| Title of Change: | Change of backside coating layer material and marking format (pin 1 appearance) for parts with backside coating |

Final Product/Process Change Notification

Document #:FPCN24594X

| | Current | Proposal |
|---------------------------------|---|--|
| Marking format of pin 1 |  |  |

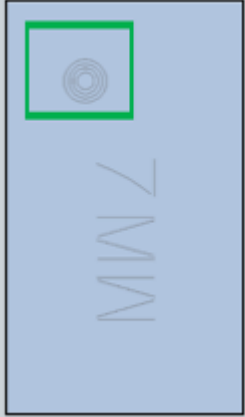
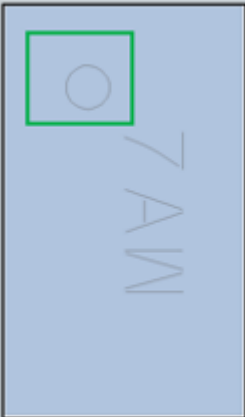
Due to quality improvement process, backside coating layer material and marking format (pin 1 appearance) for parts with backside coating will be changed:

| | Current | Proposal |
|---------------------------------|---|--|
| Backside coating layer material | LC2850 25 | LC86R25 |
